# Planning Commission

#### 4.1 Pat Briggs Planned Unit Development (PUD): Two 79-unit Apartment Buildings, Land Use Amendment, Zone Change, and Ordinance Amendment - 17379 Twin Lakes Rd NW

**Item Description**  
Pat Briggs Planned Unit Development (PUD): Two 79-unit Apartment Buildings, Land Use Amendment, Zone Change, and Ordinance Amendment - 17379 Twin Lakes Rd NW

Staff have completed a review of the application materials submitted for a multifamily apartment PUD - Land Use Amendment (LU 25-02), Zone Change (ZC 25-02), and Ordinance Amendment (OA 25-08) submitted on July 23, 2025, and have the following comments. Please address these comments with future submittals.

**SITE PLAN**

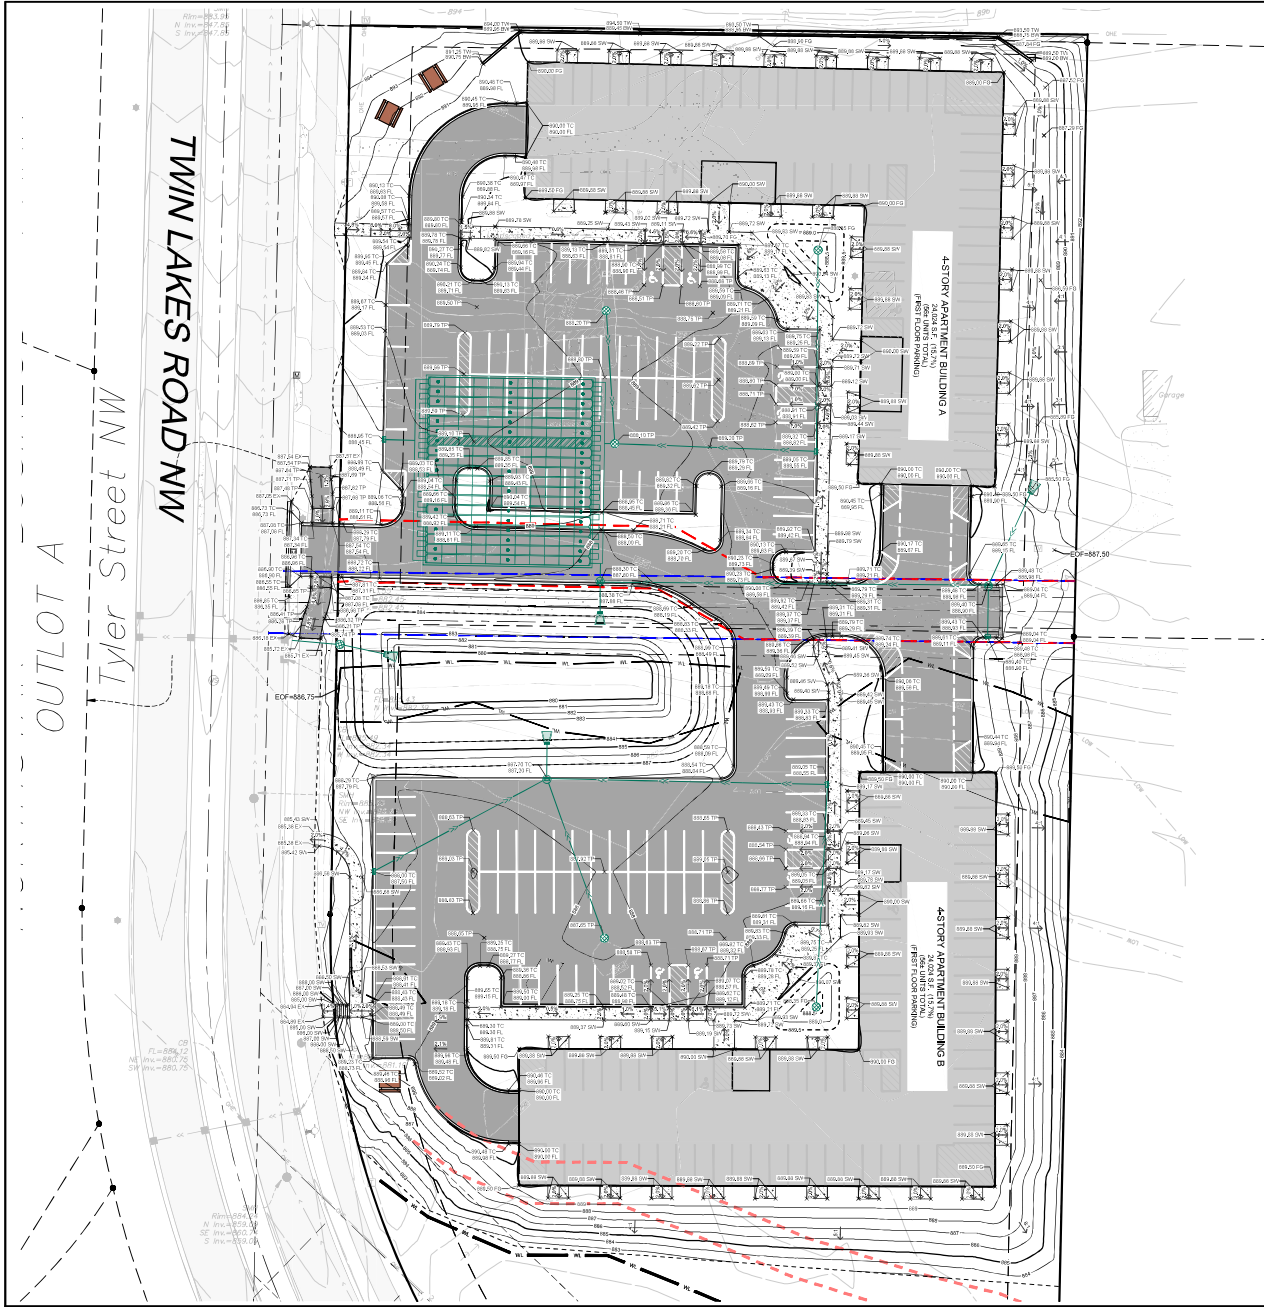
- 7. Submit plans showing all public utilities (sewer and water).
- 8. Provide an updated stormwater report to account for 1.1" of impervious rather than 1". Ensure runoff rates are decreased to all outlets including city storm sewer. Include TSS and TP removals in stormwater report.

- 11. Ordinance requires 2.5 parking stalls for each residential unit. With two proposed 79-unit buildings, 395 stalls will be required and 158 stalls (79 per building) must be covered. Submitted plans show 258 total stalls with 124 covered spaces (62 per building). This deviation will need to be approved as part of the requested PUD.

- 15. Plans indicate plans for two separate lots. A subdivision application facilitating this split is required.
- 16. The southern building is within the wetland buffer setback. Encroachment into the setback will be considered as part of the PUD. Future maintenance of the site should prohibit maintenance activities within the 25-foot wetland buffer.

**FIRST FLOOR PLAN**

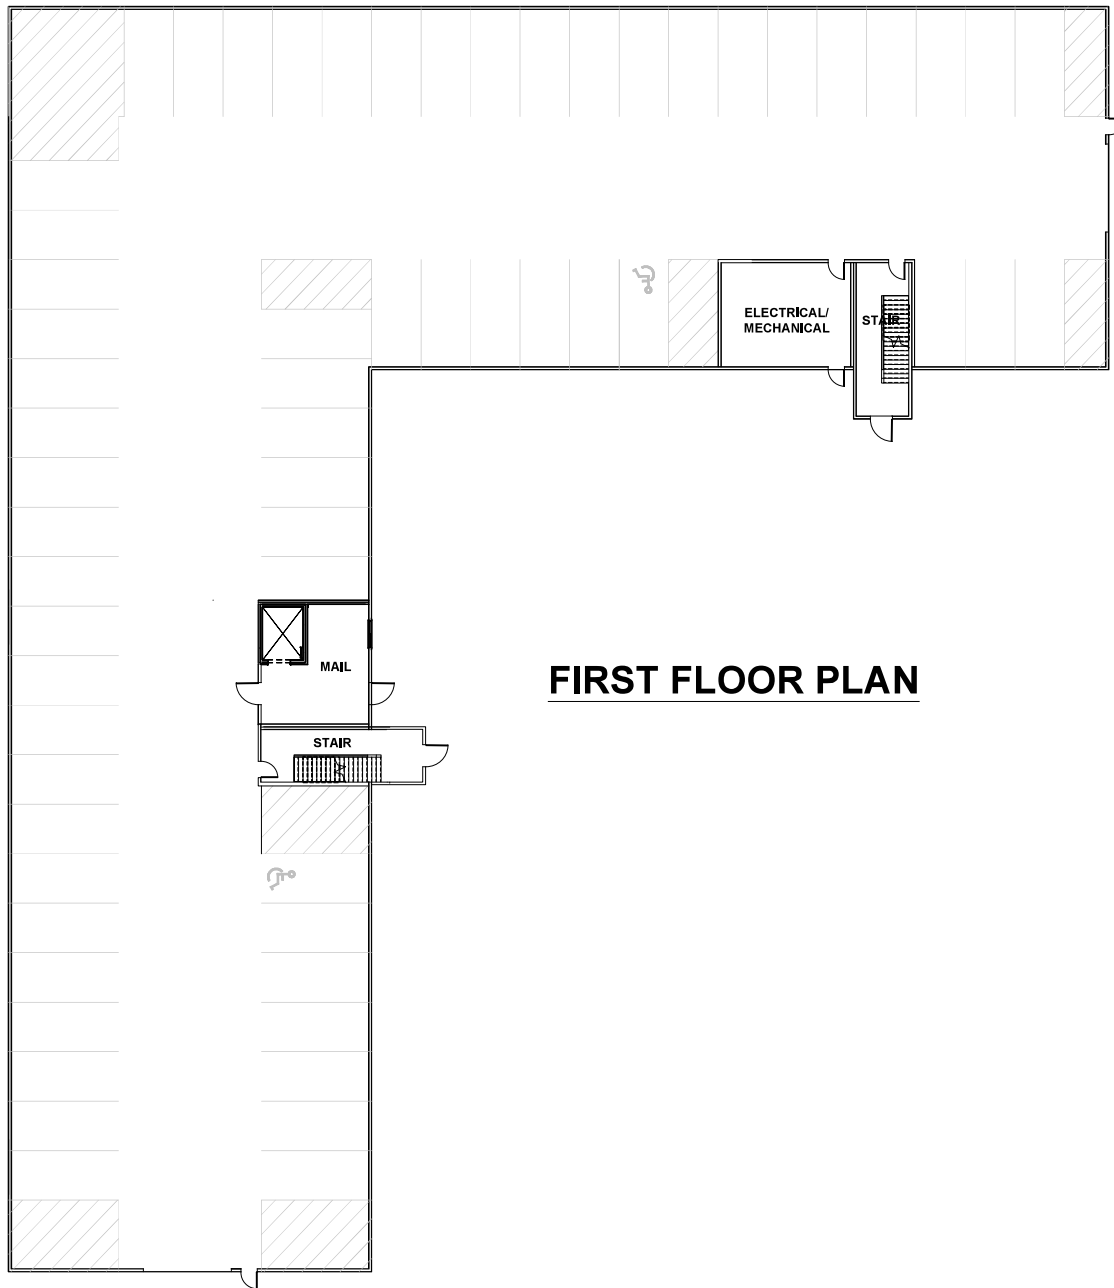
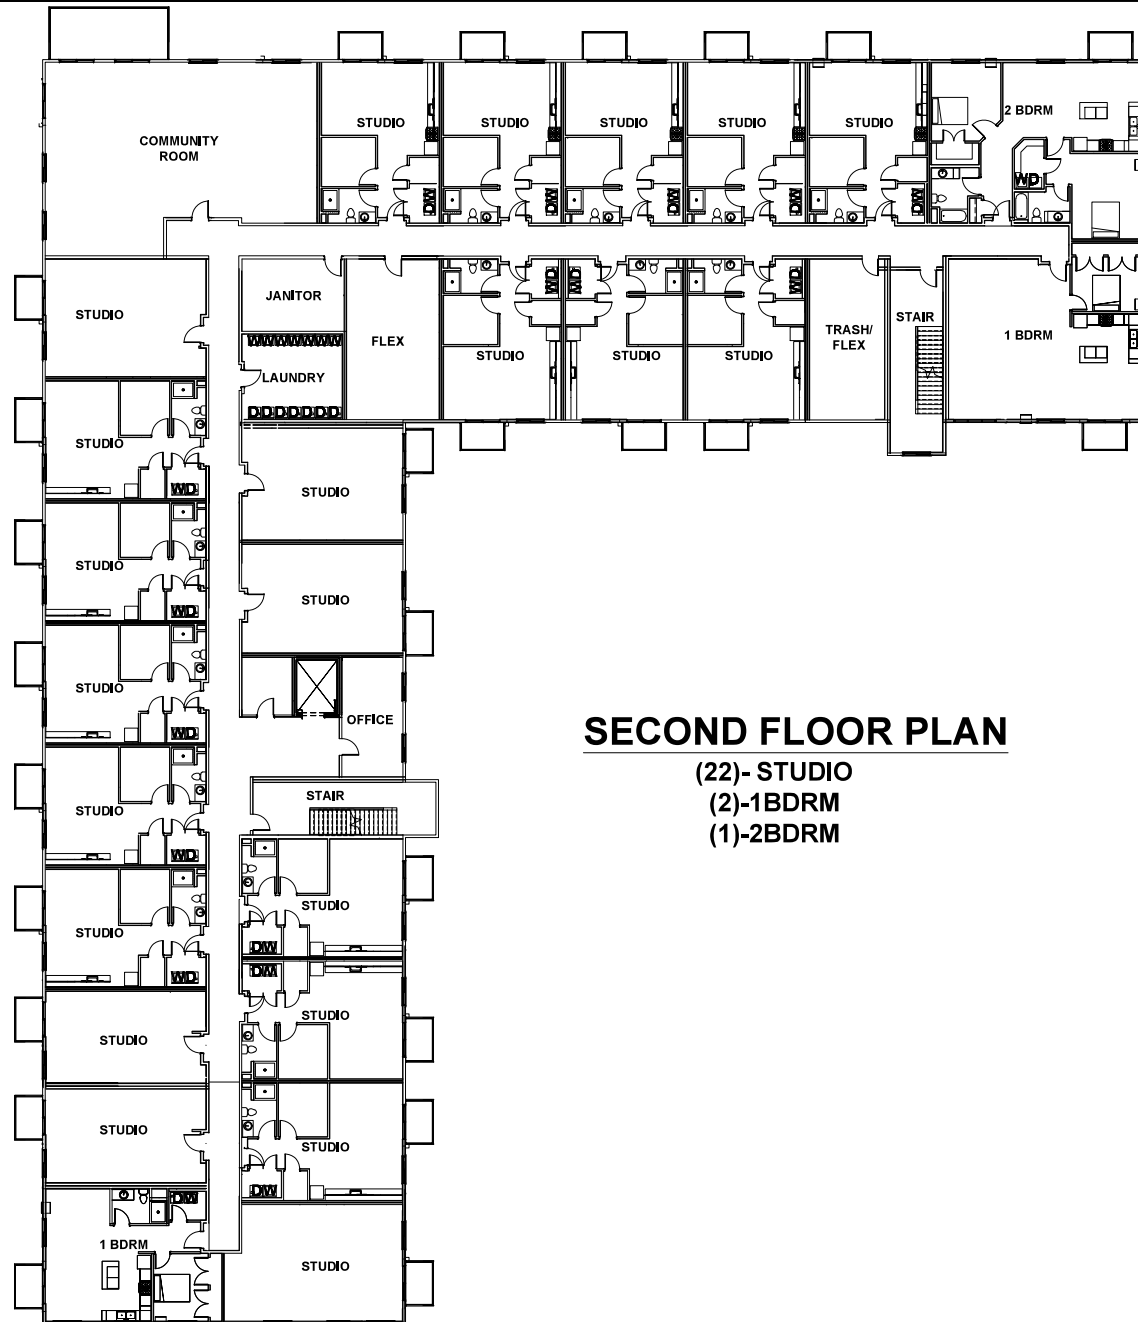
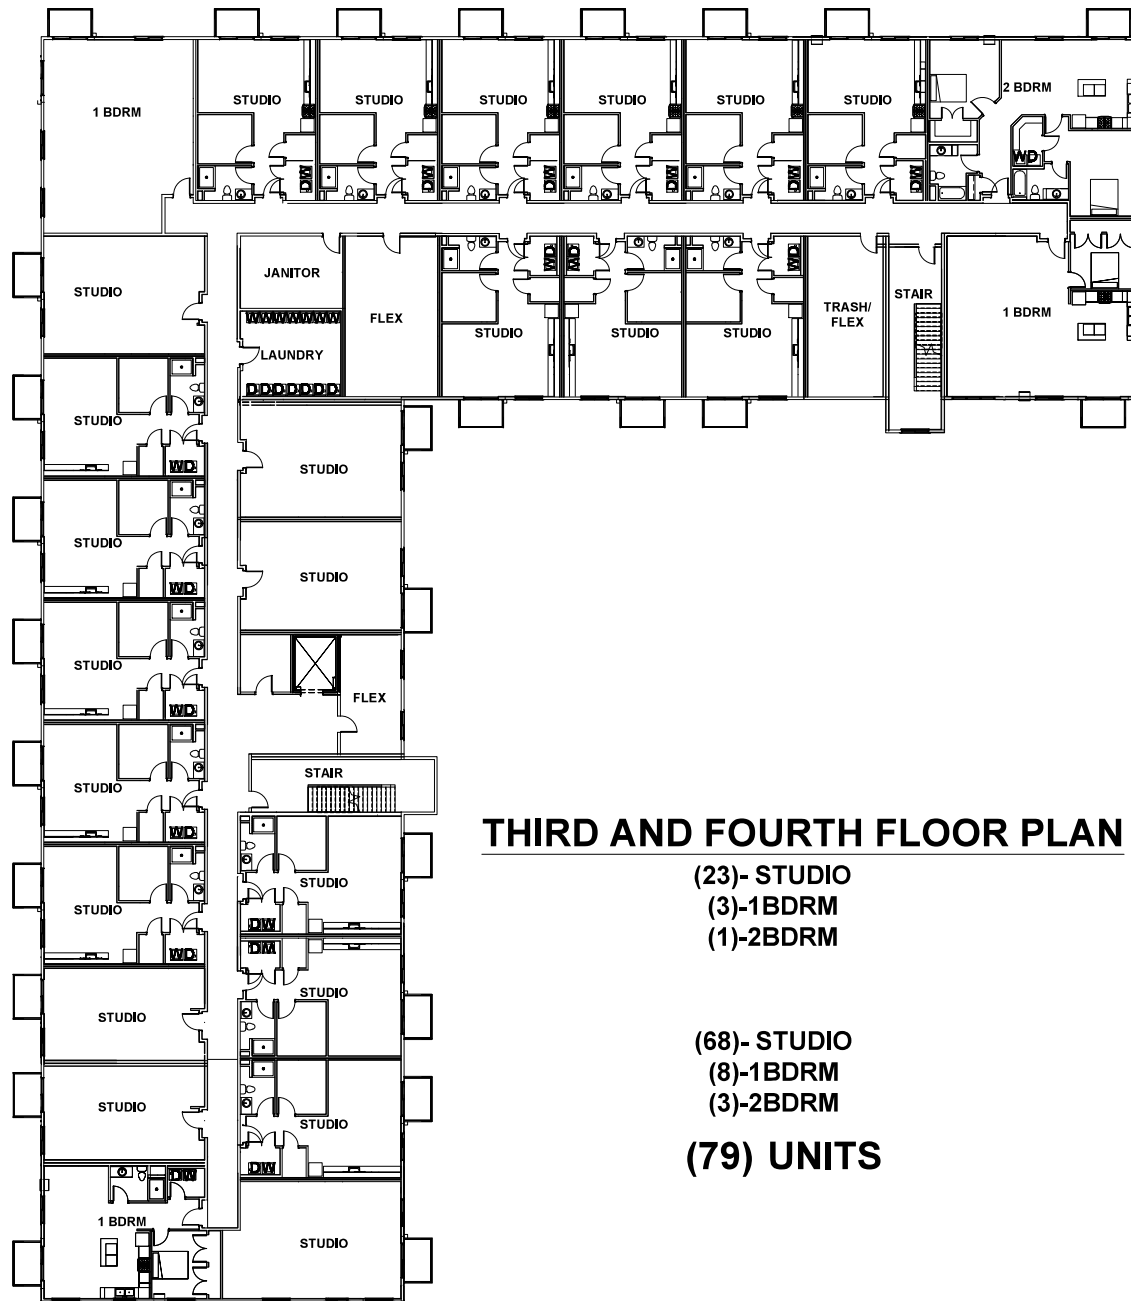
Submitted plans show an apartment building with four-stories of residential units and one floor of parking. The majority of units within each building are designated as efficiency units. The commission should discuss this distribution and make a recommendation whether the mix is appropriate.

## Parking

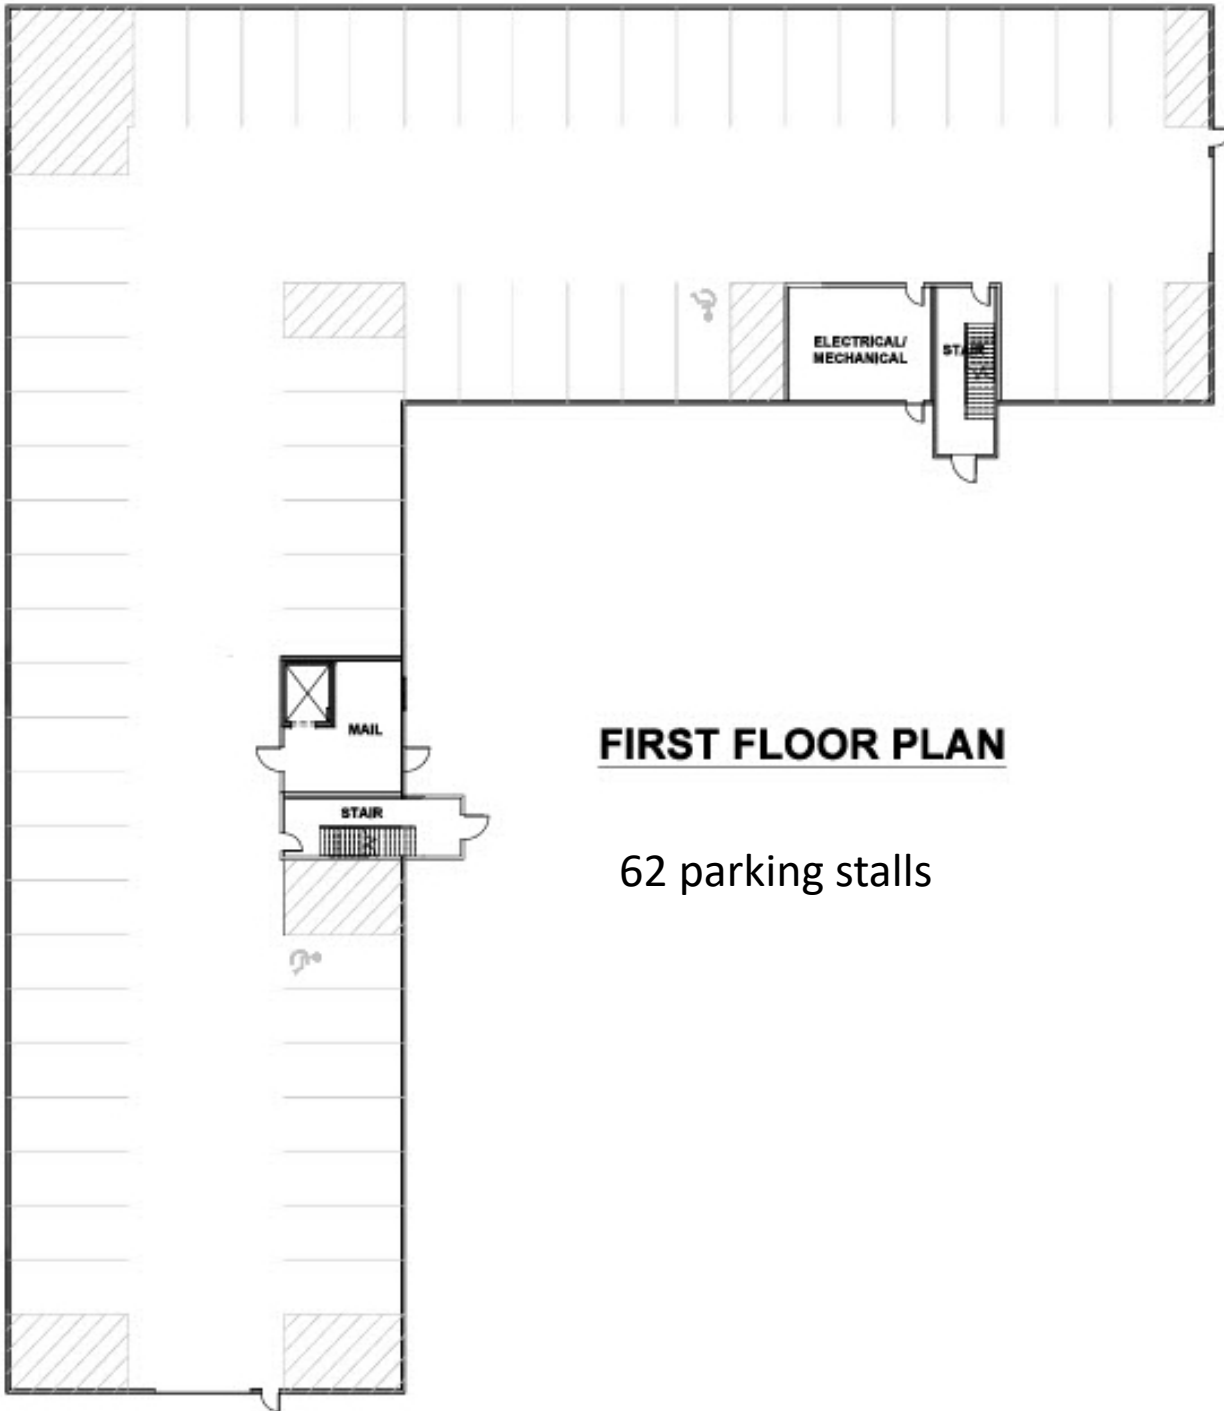
- Ordinance requires 2.5 stalls/unit – one covered.
- Plus provide 1.63 total stalls/unit
  - Deficient on covered and surface stalls.
- 2.0 stalls/unit generally approved with proof of parking.
- One project has been short on covered stalls (Common Bond).
- ER Lodge (AmericInn)

1.94/unit constructed.
